## Consultation Response: Rugby Parkway

### Consultee: Railfuture (West Midlands Branch)

### Location 1

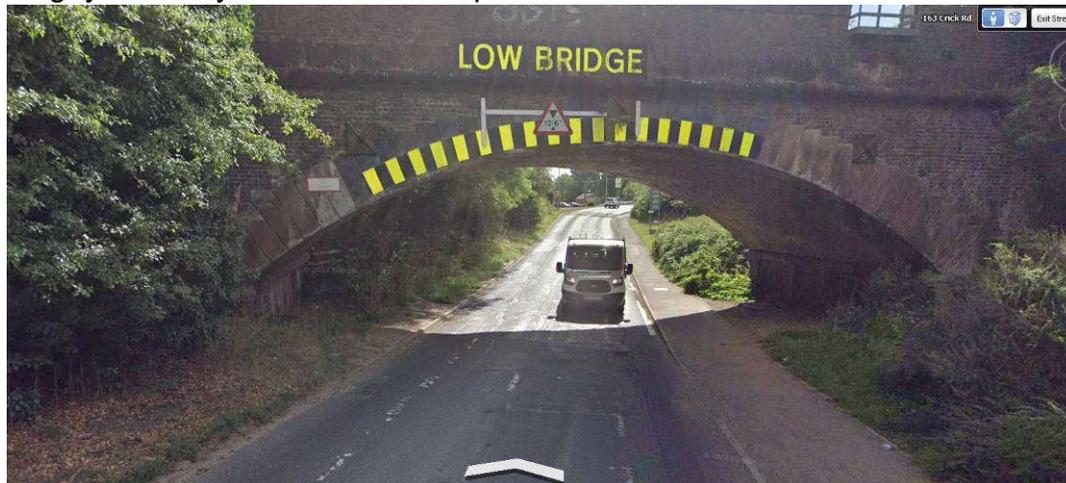
At the west end of the housing development the active travel infrastructure basically disappears

Becomes very poorly maintained footpath that isn't even large enough for a single pedestrian to be far enough from the motor vehicle lane to feel safe

Speed limit on this section of road is 40 mph.

Appears to be sufficient width to re-locate motor-vehicle lanes approx 1 metre to the left and create a  $\approx 2\text{m}$  wide shared use path.

While still below standard it would be a short distance under the bridge and is better than nothing.

Consider armco barrier to protect bridge structure on the left, and separate and protect active travellers on the right.

### Location 11

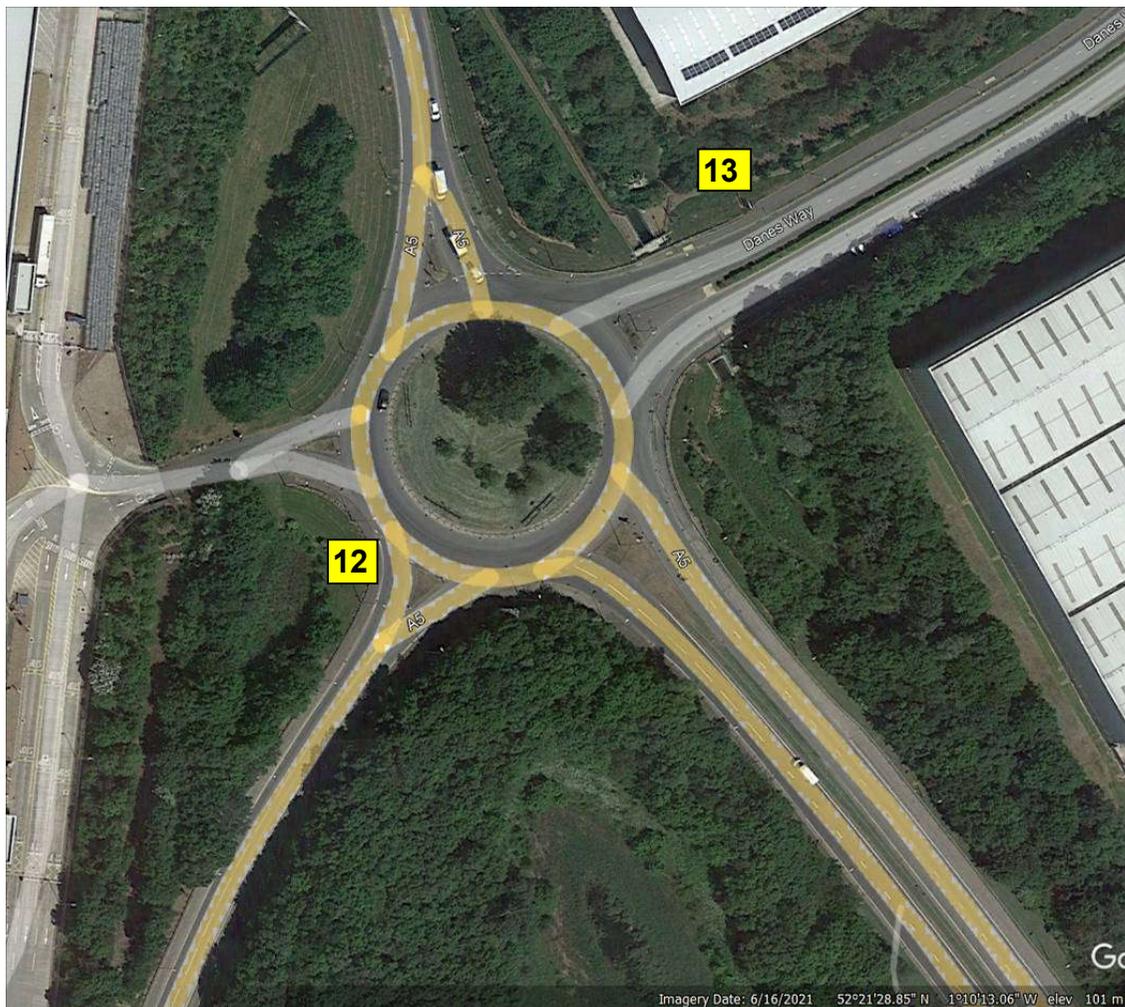
Junction not compliant with LTN 1/20 – not even an indication on the motor vehicle lanes of the existence of the active travel route, let alone of any prioritisation for active travellers.

Inadequate pavement width for bi-directional shared use path.

Armco barriers again seem to exist to protect street furniture, but offer no protection to active travellers, and are something they would be crushed against if a motor vehicle mounted the pavement.

Erecting a blue sign and doing nothing else to improve the infrastructure is not active travel provision.

Consideration should be given to Dutch style roundabout.

### **Active travel and motor vehicle lanes at junctions**

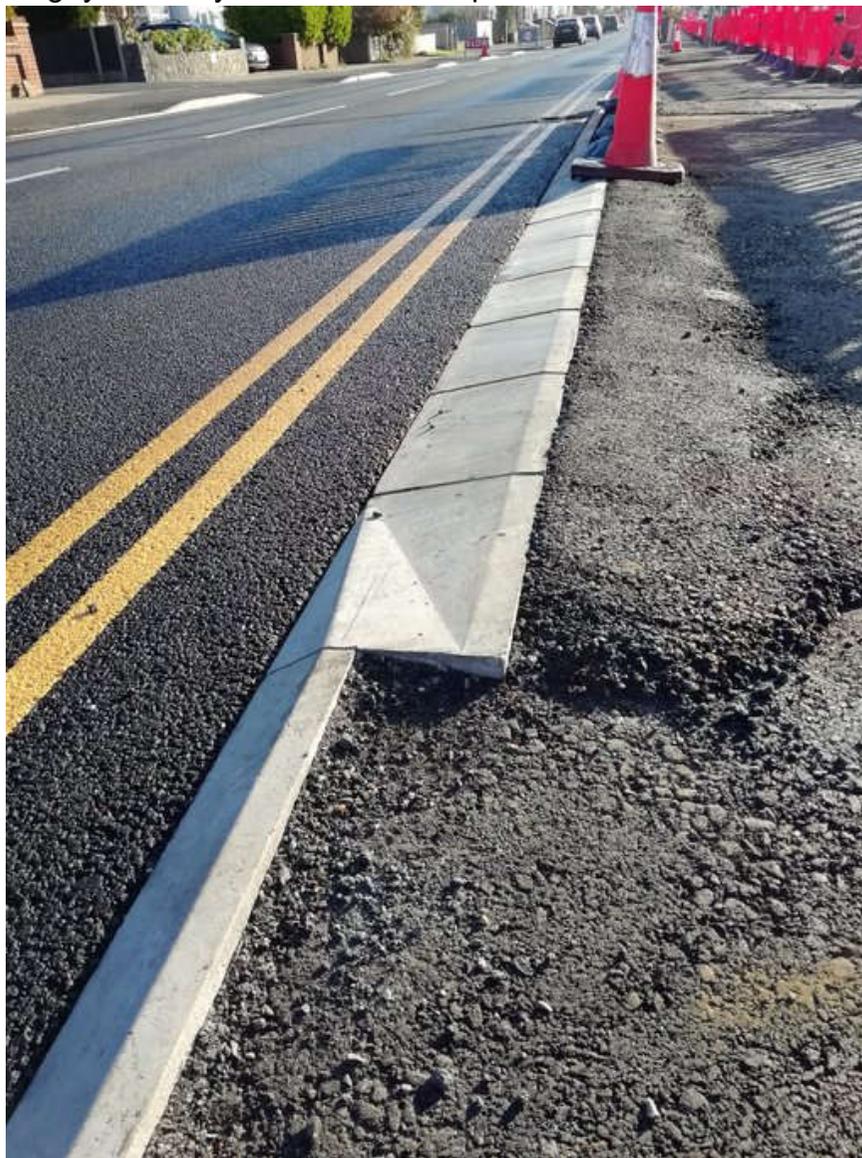
The currently preferred solution for creating crossing points between main roads and side roads where motor vehicle lanes need to cross active travel lanes is a 500mm deep kerb.

This allows the active travel route to continue and be flat without a dip, which is easier for both pedestrians (particularly mobility impaired) and also cyclists.

The height variation for motor vehicles provides a natural retardation in speed, and enforces the requirement for motor vehicles to give way.

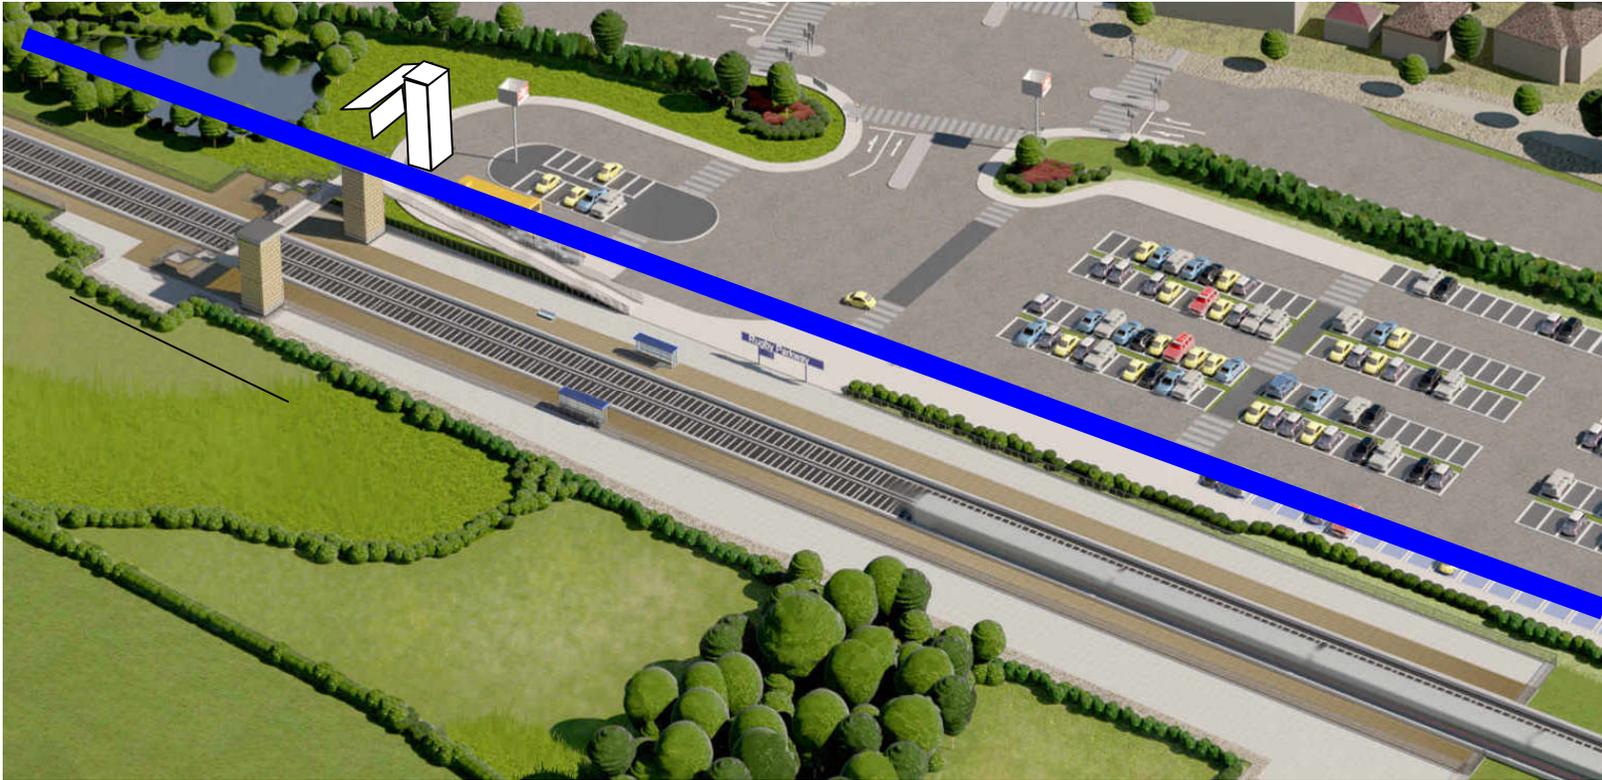
To the south of DIRFT there is a tunnel under the M1, but to the north of DIRFT is open country. A likely future capacity enhancing measure would be to add a 3<sup>rd</sup> bi-directional line to the north of the two existing lines on the Northampton loop, allowing freight trains to exit/ join the main line closer to line speed and then slow down on this 3<sup>rd</sup> line to access / exit DIRFT.

(indicative position dark blue on diagram)

For example, while no substantial structures are shown in the illustration, if there are any substantial structures it would be prudent to locate them sufficient distance north of the existing tracks to allow an additional 5m wide single track to be accommodated (as indicated in blue).

Furthermore it would be prudent future passive provision to configure the two lifts and bridge between them so that it is straightforward to continue the overbridge further north over an additional freight track, facilitating a future 3<sup>rd</sup> lift to provide access over an additional track.

i.e. simply locate the lifts to the side of the overbridge, not on the ends of it (as currently shown in render, but this design feature needs to be carried through to construction) (outlined in above diagram)
